**SPARTANBURG COMMUNITY COLLEGE – TYGER RIVER BUILDING COSMETOLOGY
RENOVATION**
DUNCAN, SOUTH CAROLINA
OSE PROJECT # H59-N306-JM | ARCHITECTS PROJECT # 653251

RESPONSE TO PRE-BID QUESTIONS

Project Name	Spartanburg Community College – Tyger River Building Cosmetology Renovation
Project Number	H59-N306-JM
Date Issued	May 23 rd , 2025

UPPER LEVEL DEMOLITION PLAN

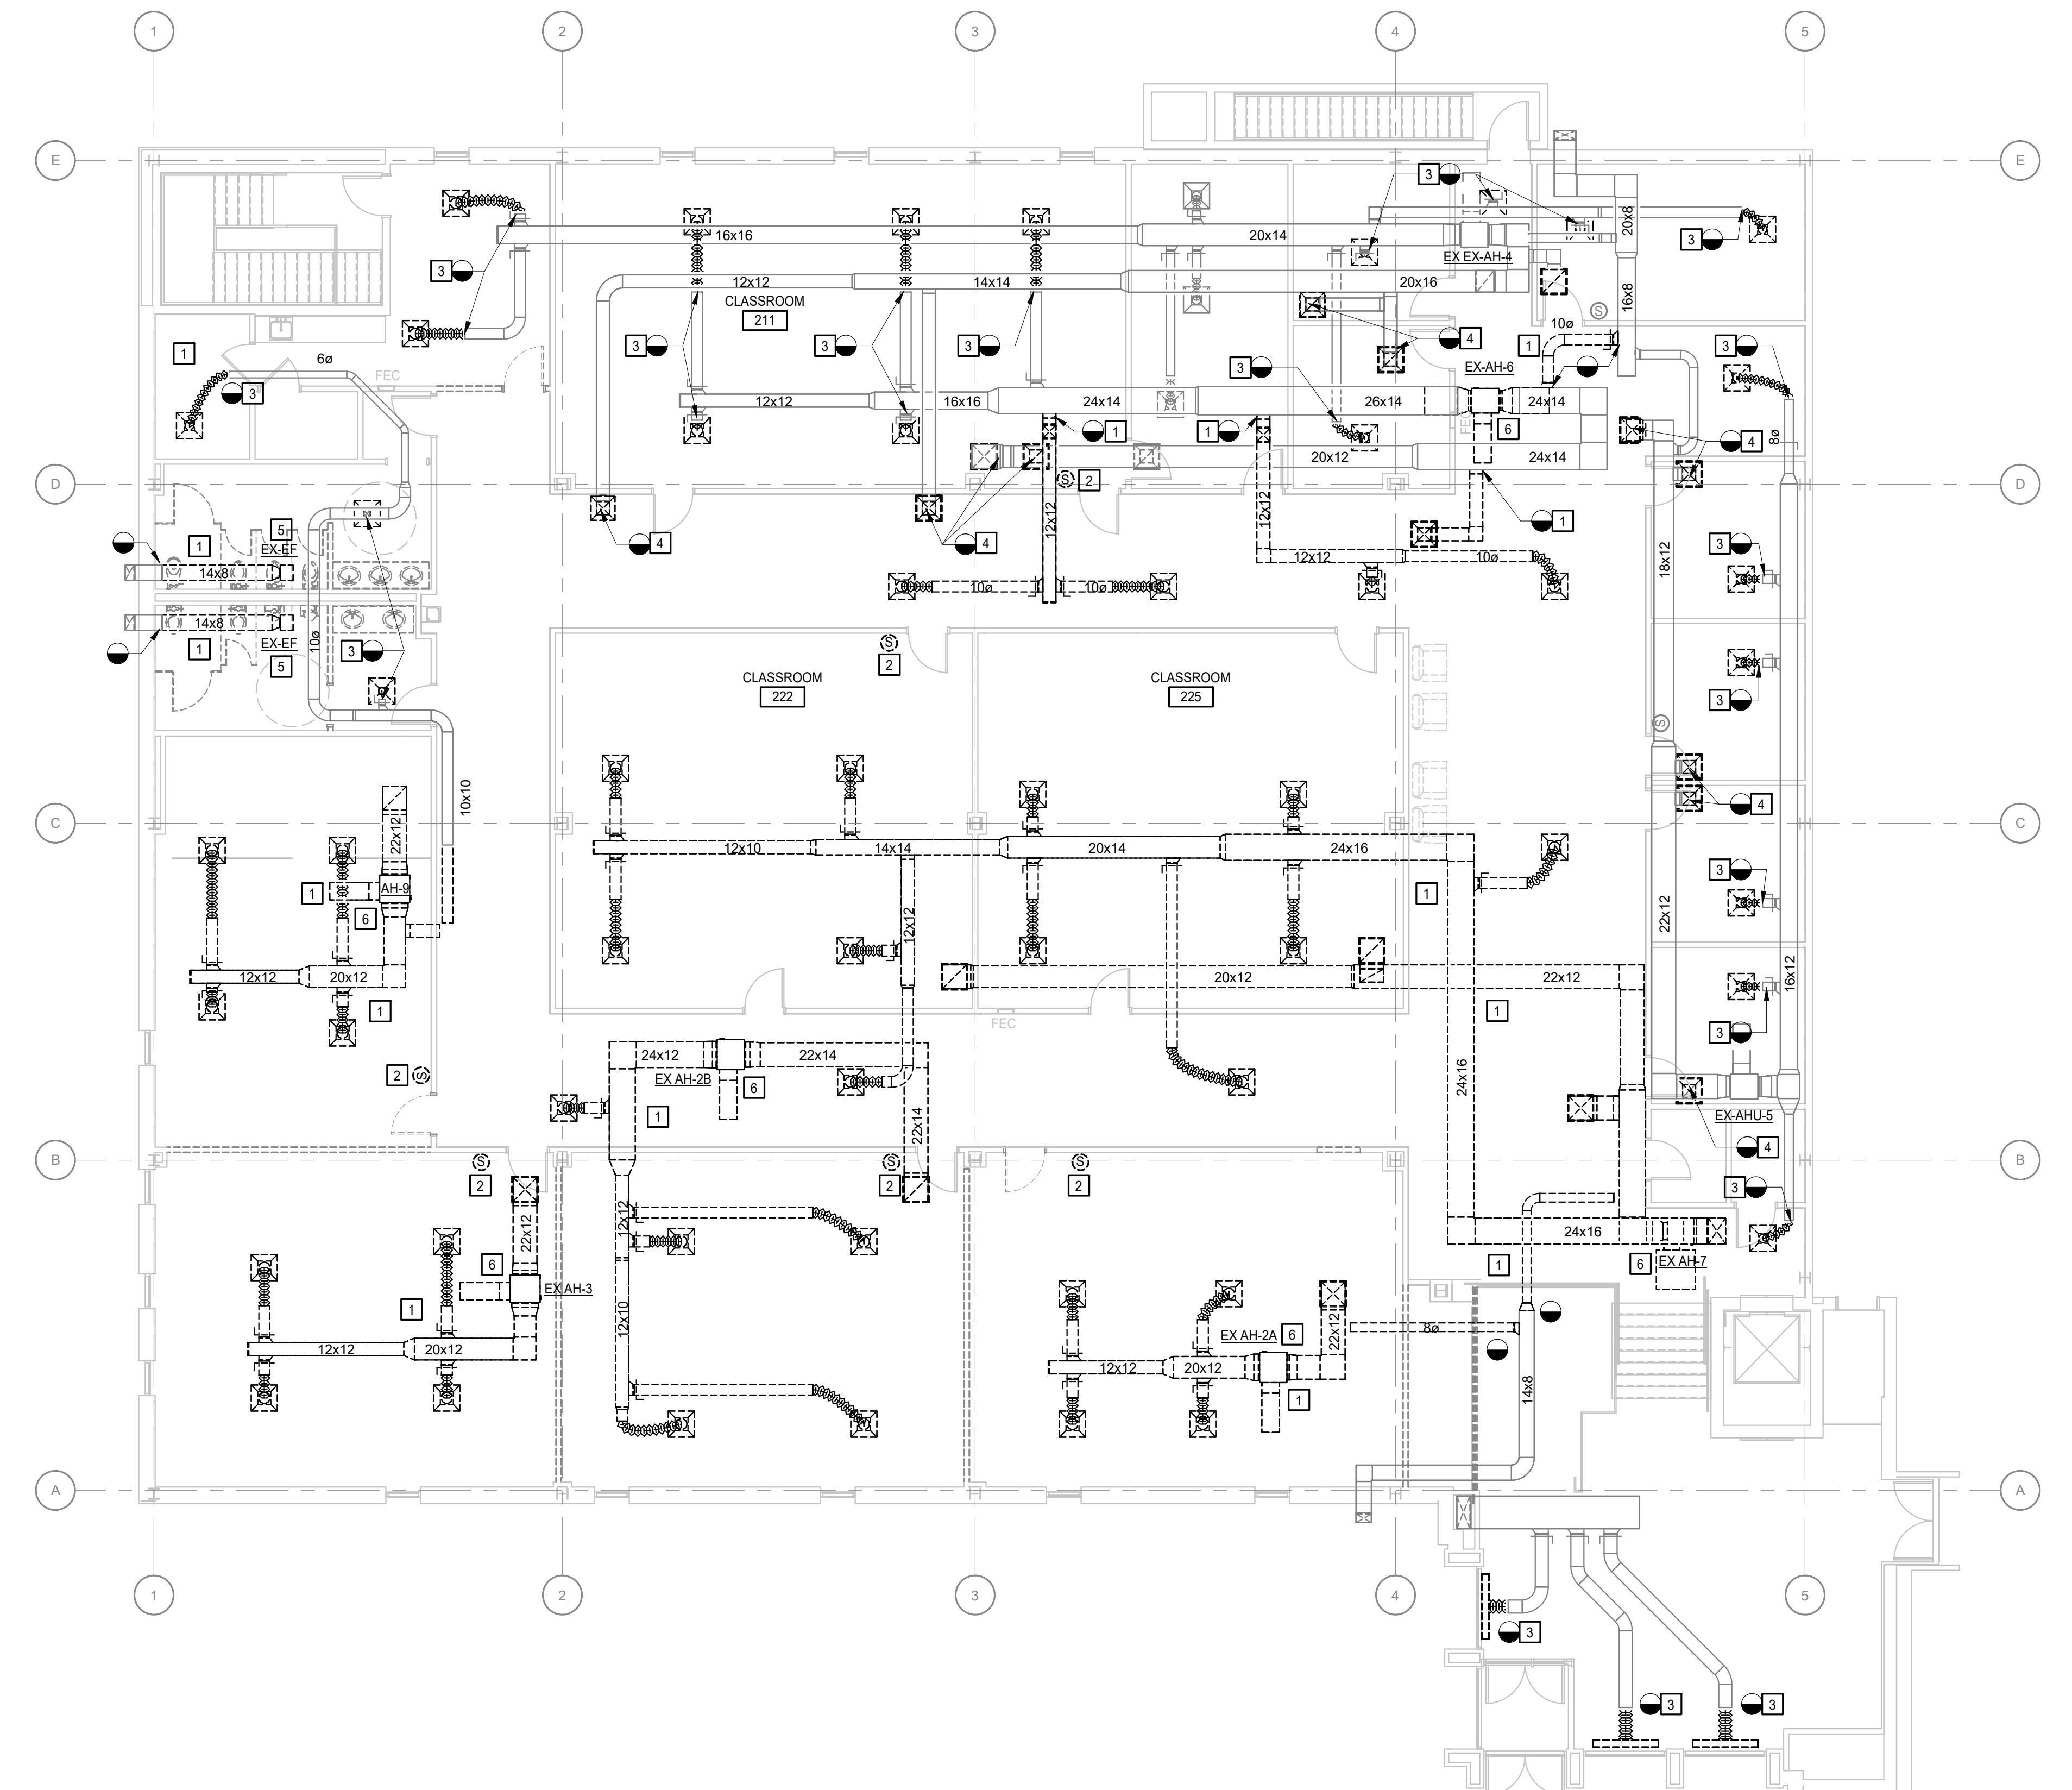
1. Mechanical drawings have been revised to indicate items to be removed during demolition are to be salvaged and turned over to the owner, as requested by the owner.

- ADDENDUM NO. 1
 - 1. REMOVE DUCTWORK AND DIFFUSERS SHOWN DASHED.
 - 2. REMOVE THERMOSTAT AND CONTROL WIRING COMPLETELY.
 - 3. REMOVE DIFFUSER AND FLEX DUCT. PREPARE FOR NEW CONNECTION.
 - 4. REMOVE RETURN GRILLE AND TRANSITION DUCTWORK. PREPARE FOR NEW CONNECTION.
 - 5. REMOVE EXHAUST FAN, CONTROLS AND DUCTWORK SHOWN DASHED.
 - 6. REMOVE AHU UNIT AND ASSOCIATED CONTROLS.
- ADDENDUM NO. 1

- ADDENDUM NO. 1
 - A. DUE TO LIMITED ABOVE CEILING ACCESS, EXISTING DUCTWORK SIZES ARE APPROXIMATE.
 - B. ALL EXISTING EQUIPMENT AND CONTROLS, CONTROLLER, VALVES AND THERMOSTATS ETC. NOTED TO BE REMOVED SHALL BE SALVAGED AND PRESENTED TO THE OWNER FOR DETERMINATION OF WHAT EQUIPMENT AND CONTROLS WILL BE RETAINED BY THE OWNER AND WHAT WILL BE DISPOSED OF.
